**Subject:** Re: 22-RSUB-0008

Thank you for taking the time to consider my feedback. I write with respect to Case Number 22-RSUB-0008 and specifically the Staff Review Comments entered 10/05/2022. I wish to draw your attention to PDS Item #3:

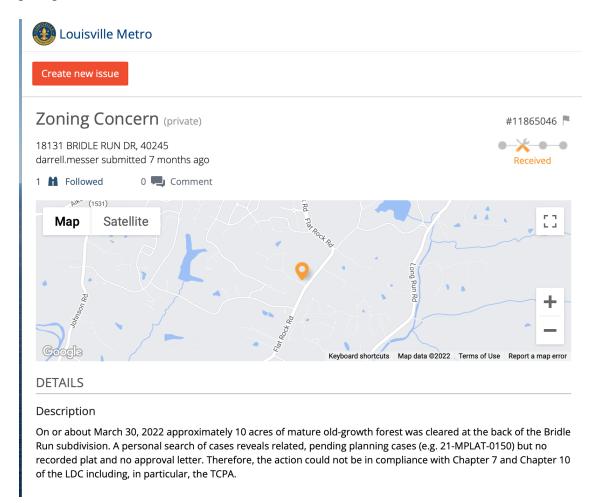
Thanks for the suggestion. I have actually already submitted an inquiry to Metro 311... 7 months ago. I'm still waiting on a response. They have absolutely cut several acres of trees and begun grading the area north and west of the retention basin. I have video from the day they did it. Perhaps the extraordinary measure of copying the Code Enforcement Board will prompt action.

I don't see any clearing and grading plans beyond what you reference. If you believe they are clearing land in violation of approved plans, I would recommend contacting 311 to file a report and it will be routed to an inspector.
